HISTORIC DISTRICT COMMISSION NOTICE OF DENIAL

Application Number: HDC2026-00100

NAME: Todd Hamula		COMPANY NAME: Zaremba Group, LLC	
ADDRESS: 14600 Detroit Avenue	CITY: Lakewood	STATE: OH	ZIP: 44107
PROJECT ADDRESS: 4612 Woodward Avenue			
HISTORIC DISTRICT: Garfield Building			
SCOPE: Install black vinyl screens

PROPOSED MODIFICATION TO EXISTING LOWER LEVEL STOREFRONT WINDOWS

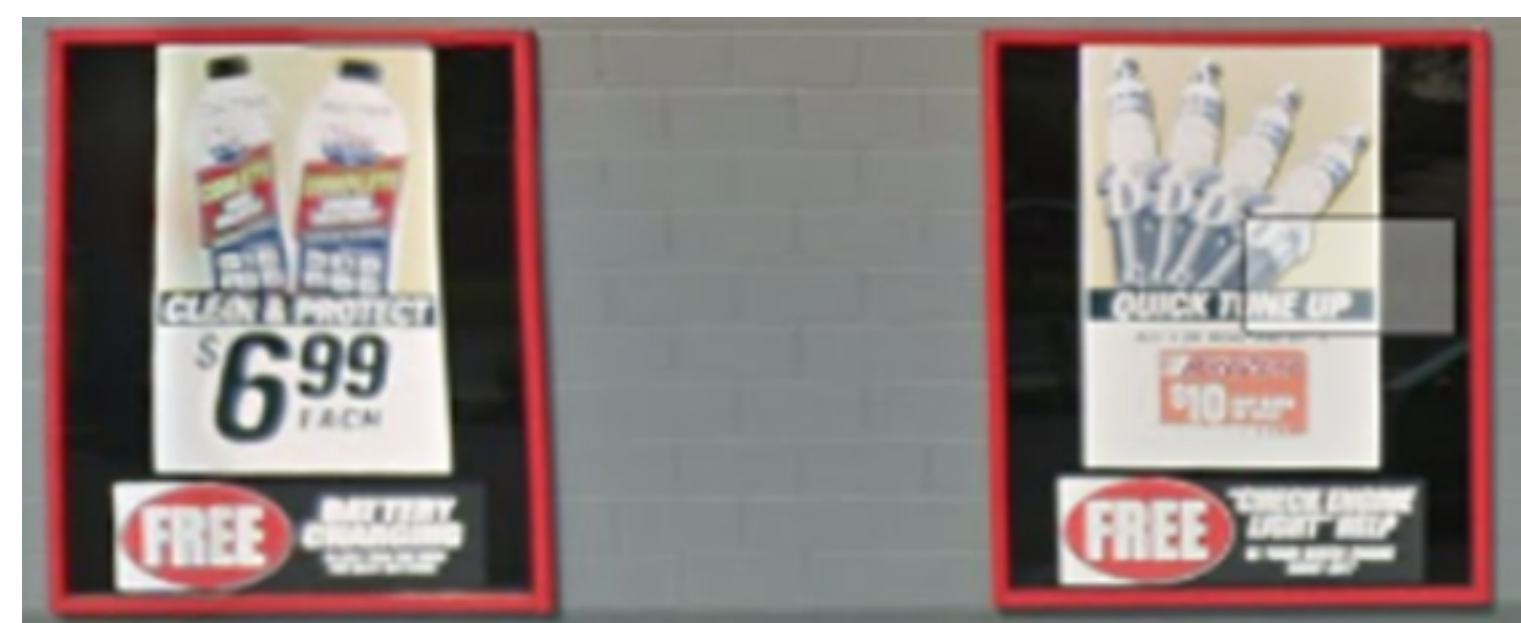
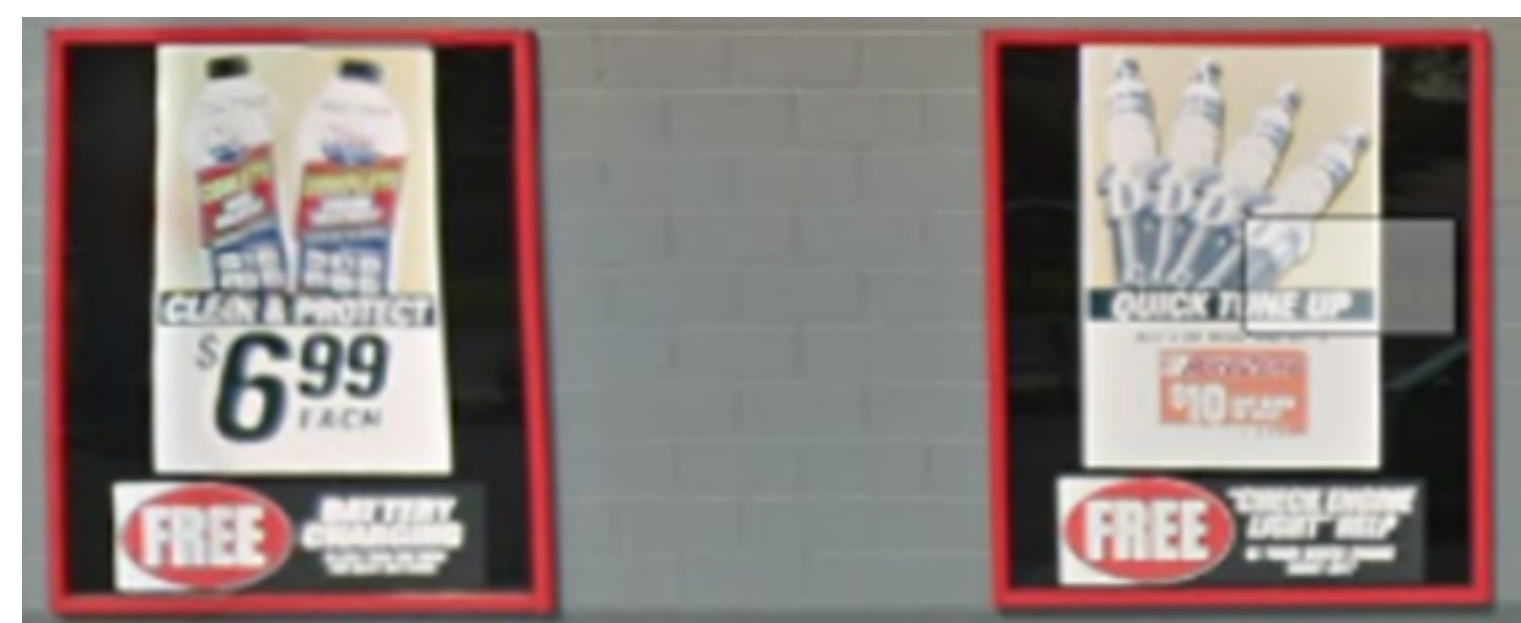
Both the installation of the black vinyl screens inside the storefront windows and the installation of the 'AutoZone' advertisements to the outside of the windows will alter the storefronts and their features. This will consequently diminish the historic character of the building.
